Wiltshire Council Planning Consultation Response

Janice Gooch
Senior Conservation Officer
Wiltshire Council Conservation (Central)

Application No: PL/2026/04751
Relocation of a boundary wall.
Bremilham Mill House, Foxley, Malmesbury, SN16 0JH

Google Maps (2026) and Site Visit Photos 31.03.25 (PL/2025/01159). Green arrow shows the different location of the boundary wall, and the blue arrow shows taller stone boundary wall, which could be curtilage listed (pre-1948).

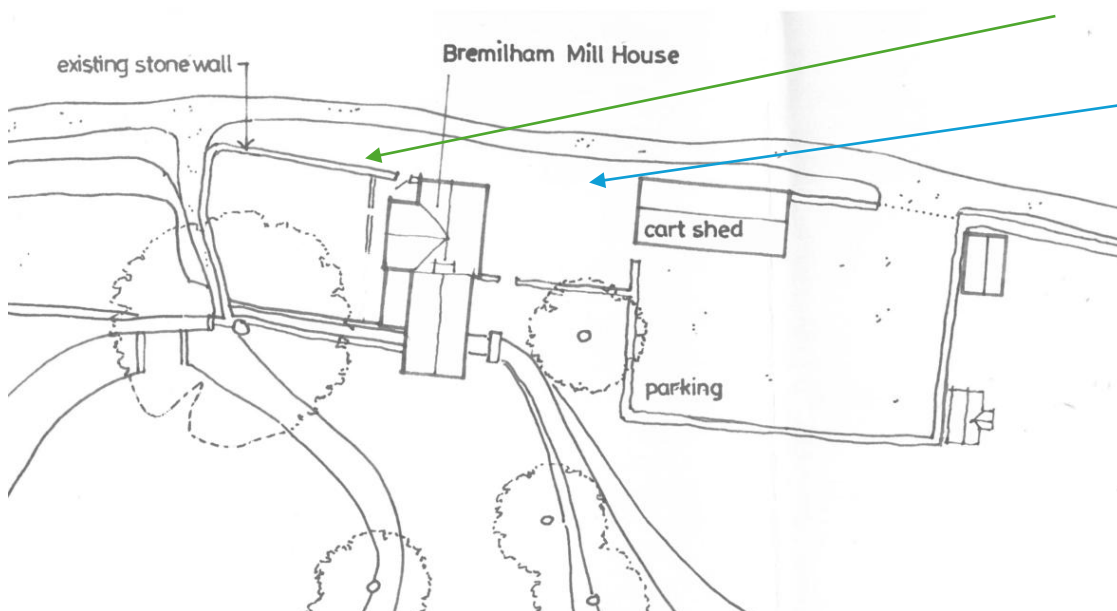
The existing site plan does not match the site visit photographs or the Google images. The previous two applications (for additional shed and greenhouse) show a slightly revised layout, with a boundary wall around the parking area to the cart shed. There is a discrepancy between the site plans regarding the boundary wall between the house and cart shed, which is shown on the site visit photographs but not on the existing site plans. This wall appears to have been constructed post 2000’s judging by the planning history.

Proposed (as approved) site plan showing new wall – 00/01850/FUL, approved 09/2000, with the boundary wall between dwelling and cart shed.

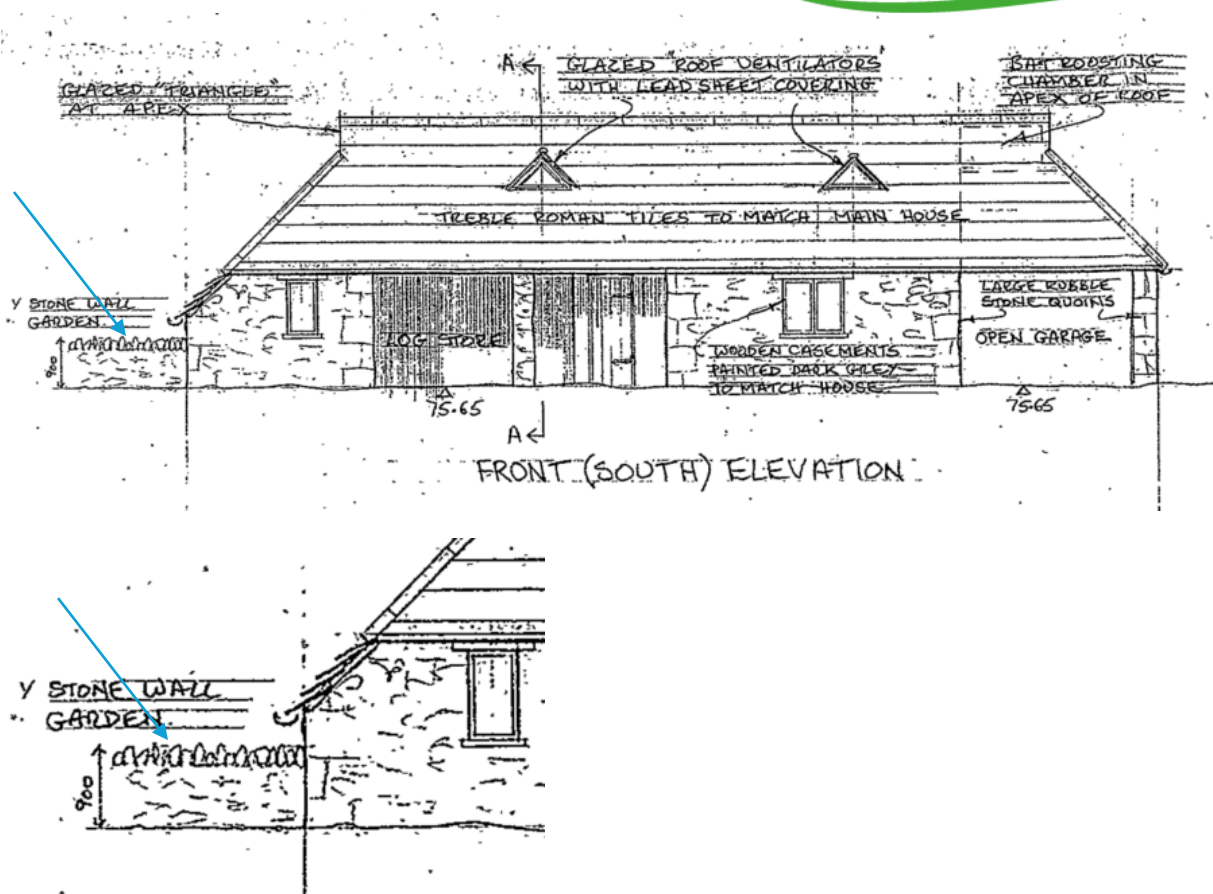
97/00358/LBC – notes ‘make good remains of stone walls and build up to 900mm’, with the position of the wall in a slightly difference location.
